FDI	ENGINEERING CHANGE ORDER		ECO NO: 09-008
			Page 1 of 1
TITLE	DWG NO.	CURRENT REV	NEW REV
ARMCARRIER Board	ARMCARRIER	1.1	1.2

FDI	ENGINEERING CHANGE ORDER		ECO NO: 09-014
			Page 1 of 4
TITLE	DWG NO.	CURRENT REV	NEW REV
ARMCARRIER		1.2	1.3

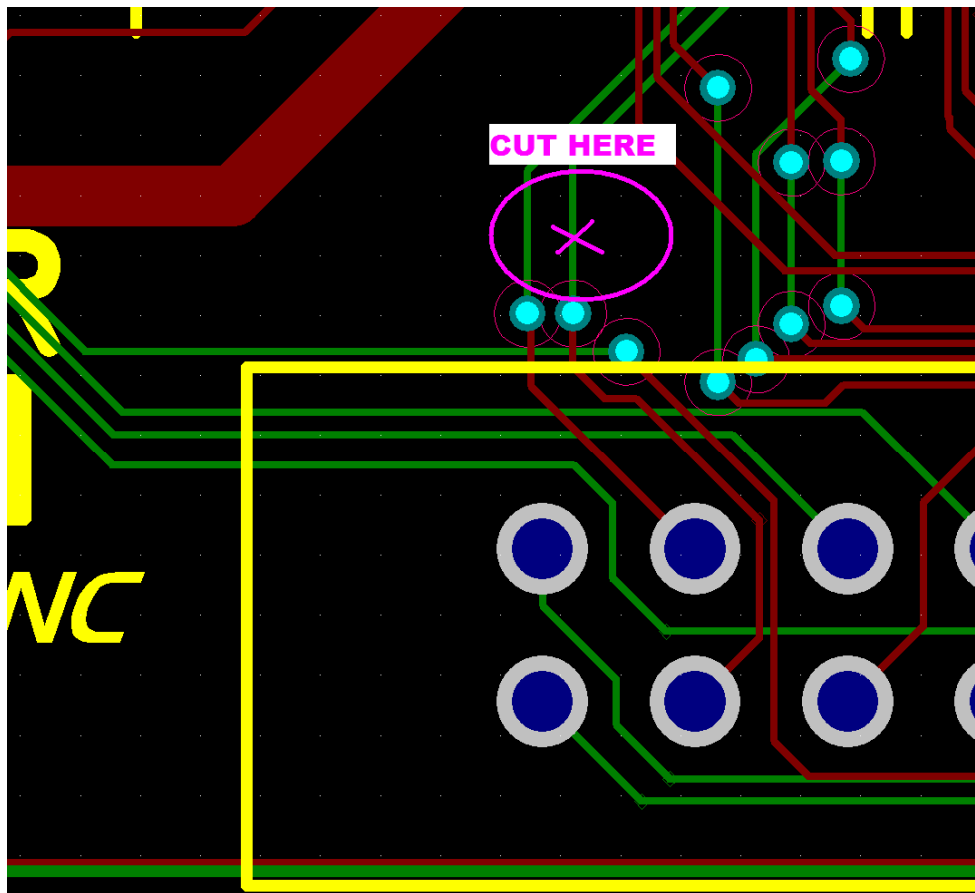
CUT:

On the bottom side, cut the trace coming from the via connected to J7 pin 48

(see illustration below)

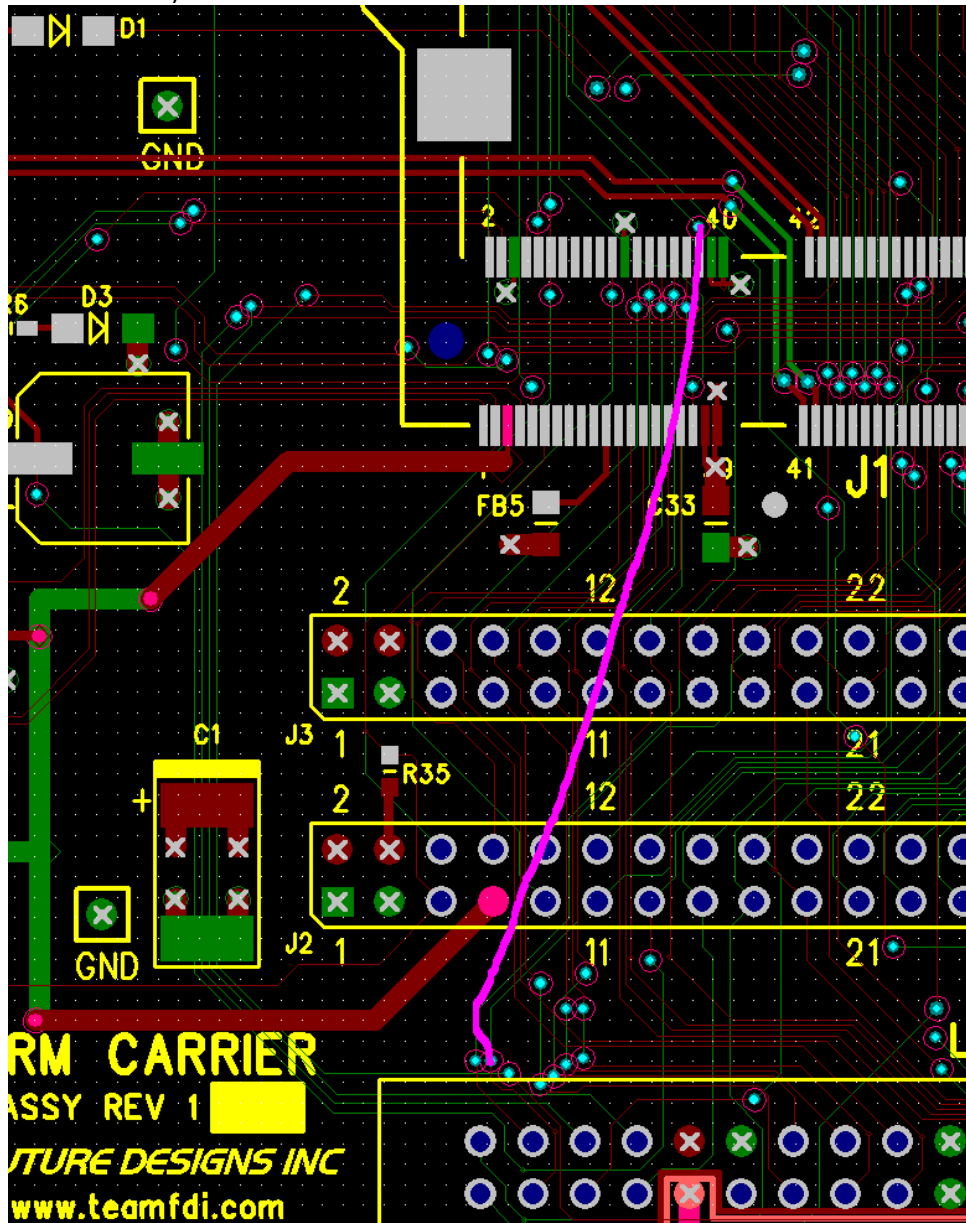
JUMPER(S):

- 1) On the bottom side, add a jumper from the via previously cut (J7 pin 48) to J1 pin 36 (see illustration below)
